# PLANNING DIVISION

## GENERAL APPLICATION

Location Address: 3255 Hollywood Blvd, Suites 1 and 2

HOLLYWOOD HILLS PLAZA OUTPARCEL  
FINAL TAC SUBMITTAL

NOTE: SIGN AREA IS BASED ON 1 S.F. PER 1 L.F. OF TENANT'S FRONTAGE PER THE CITY OF HOLLYWOOD SIGN ORDINANCE, AND ONLY ONE SIGN IS ALLOWED PER STREET SIDE.

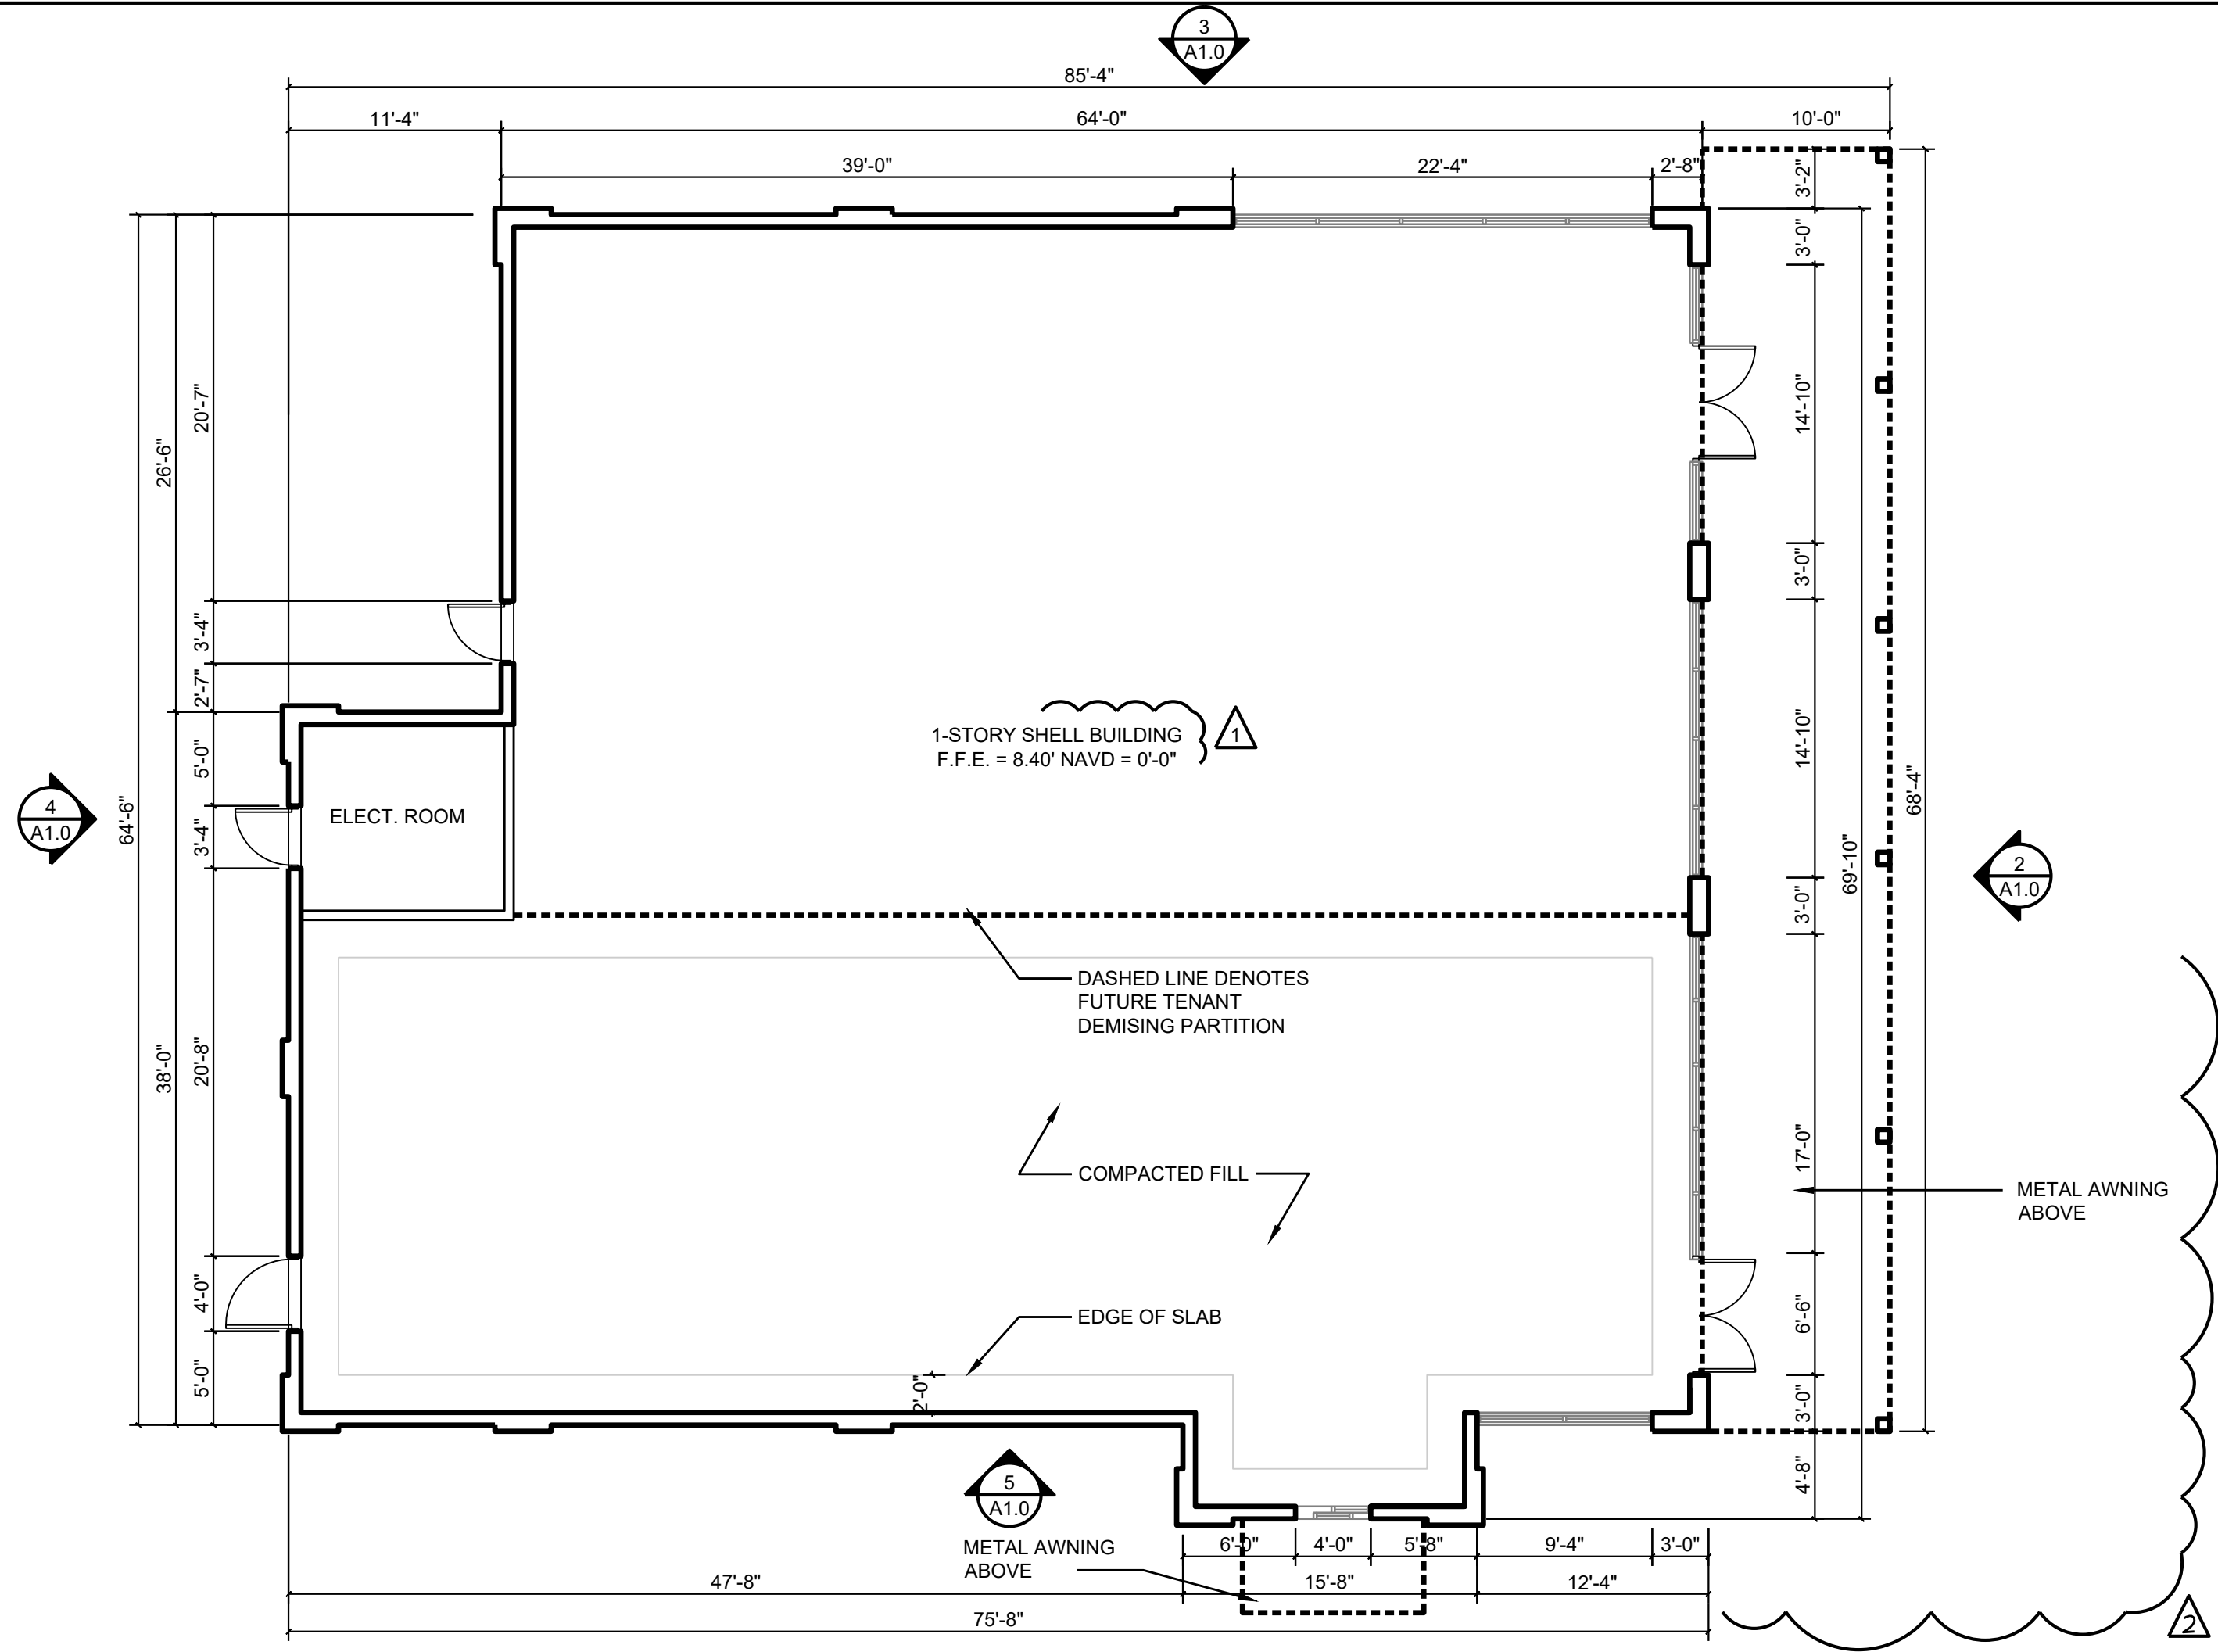
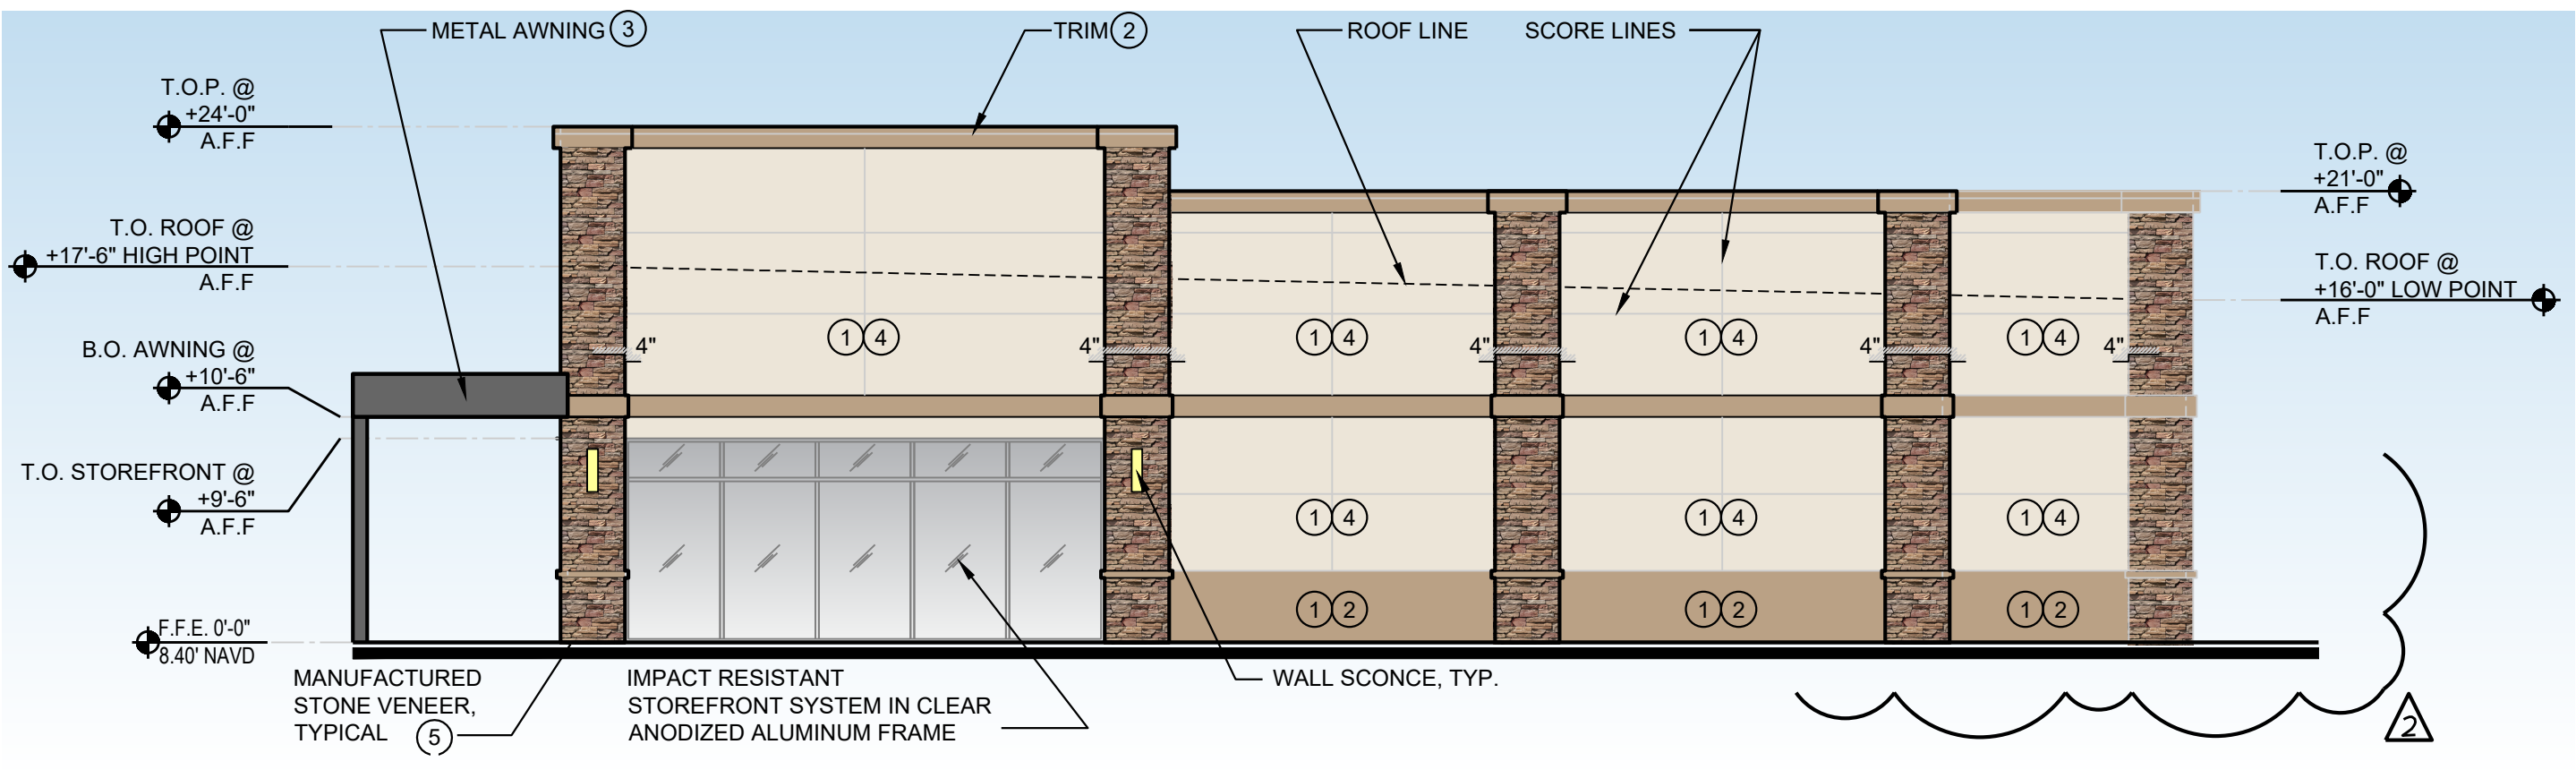
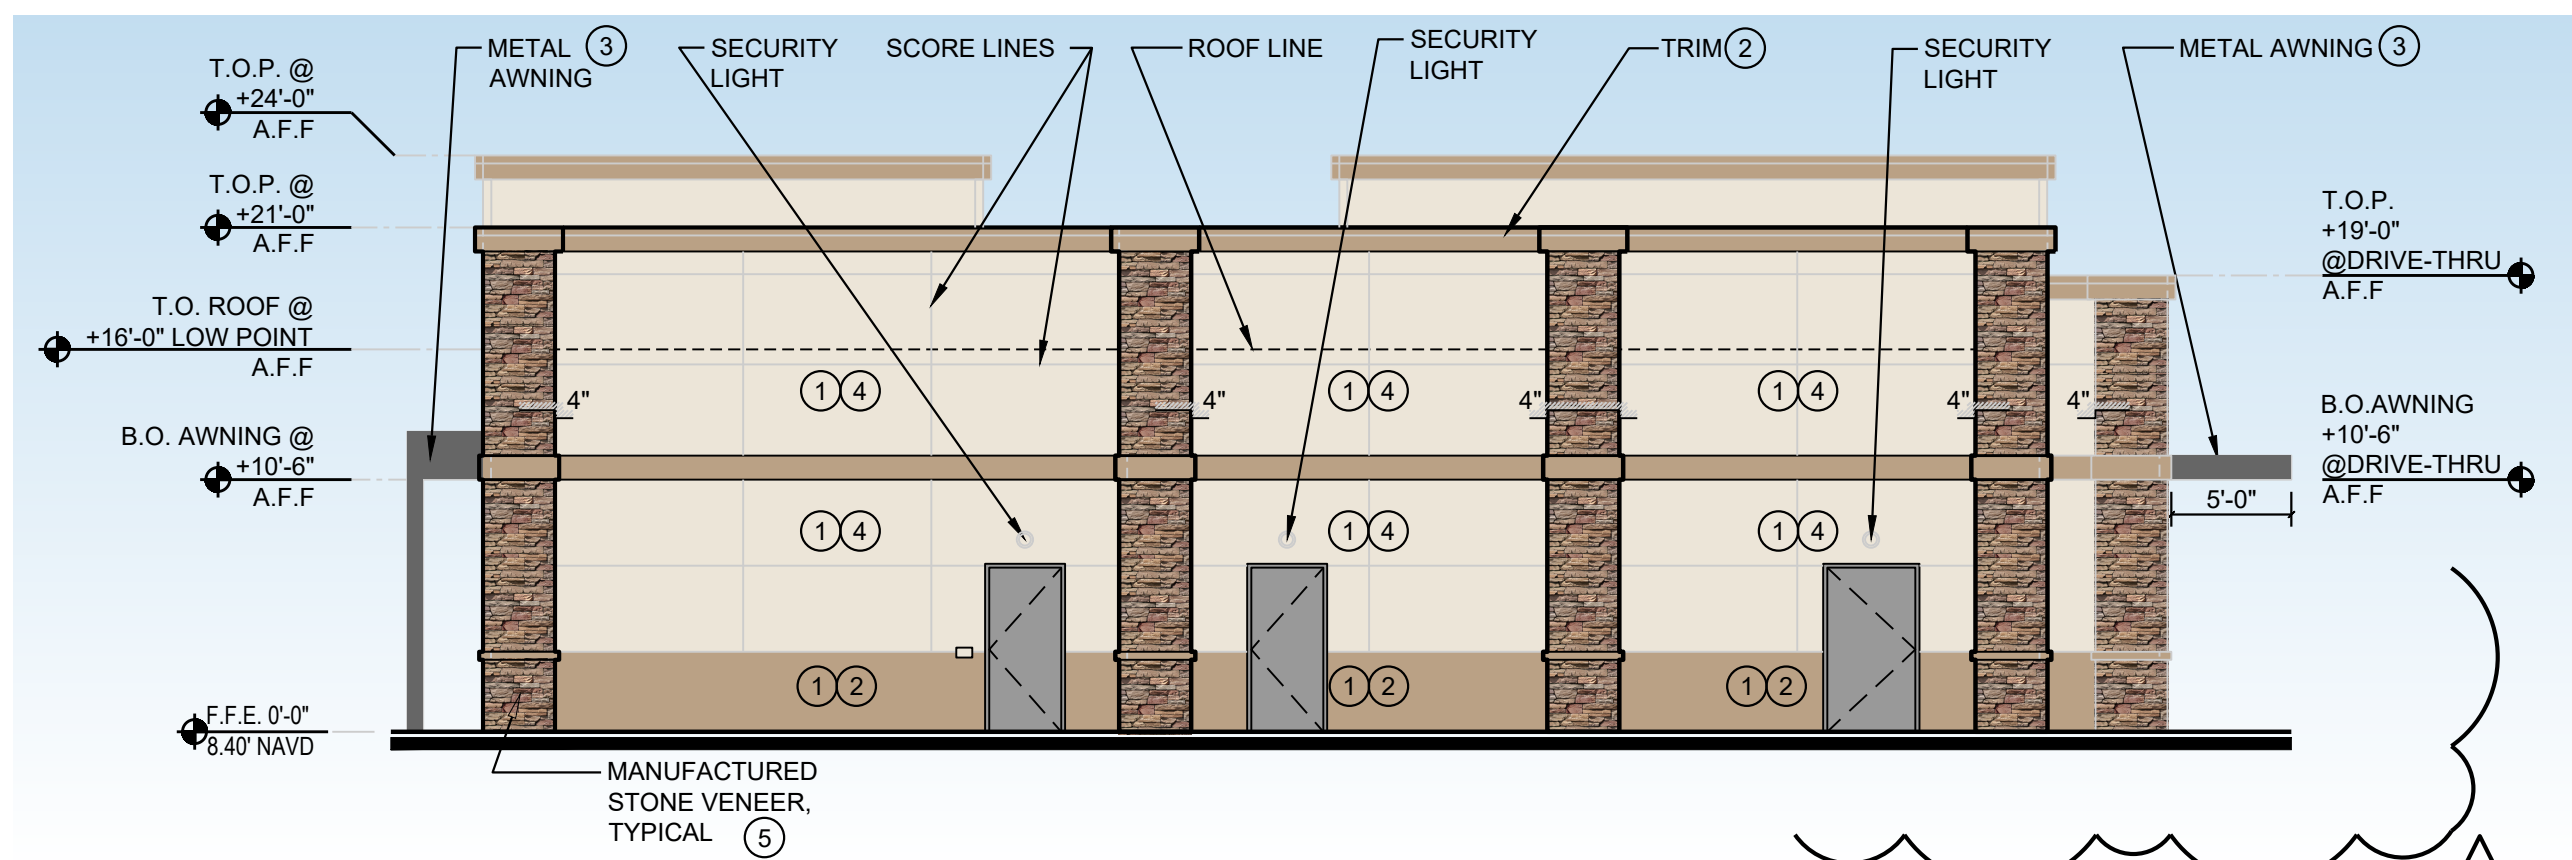
1. Comment: Given the outparcel's location within a shopping complex, the project should incorporate addition architectural articulation on the north and west facades.  
**Response:** *The elevations have been revised as requested. Please refer to sheet A1.0.*
